Unit Injector Yoke Hold-Down Bolt Torque Specification VN, VHD, VAH, VT

FSB 237-020, Unit Injector Yoke Hold-Down Bolt Torque Specification

(September 2017)

W2124666

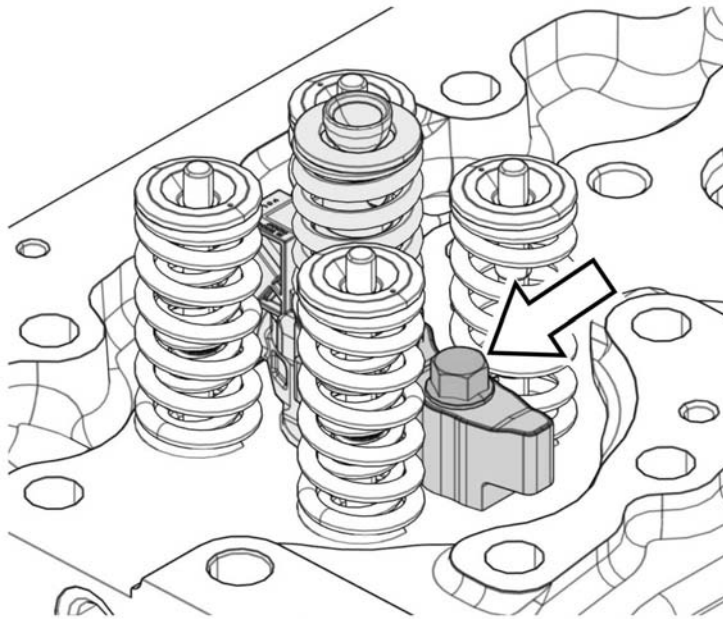
VOLVO VN, VHD, VAH, and VT trucks built from 2009 to 2017 and equipped with 11, 13, and 16 liter engines (EM-USA10, EM-USA14, and EM-USA17), will require a new torque specification for the Unit Injector Yoke Hold-Down Bolt. Effective immediately, the torque value in step 4 has changed to 25 +5/-0 Nm (18 +4/-0 ft-lb). See the torque procedure in steps 1 through 5 below. Additionally, the new yoke hold-down bolt torque will be updated in all service procedures, methods, and specification manuals.

Note: If the unit injector yoke hold-down bolts are removed, do not reuse. The unit injector yoke hold-down bolts are made for one time use only.

- 1 Tighten 20 +5 Nm (15 +4 ft-lb).
- 2 Tighten 180 ±5 degrees.
- 3 Loosen the bolt until the torque is 10 to 15 Nm (7 to 11 ft-lb), back off approximately 150 Degrees.
- 4 Tighten 25 +5/-0 Nm (18 +4/-0 ft-lb).
- 5 Tighten 90 ±5 degrees.
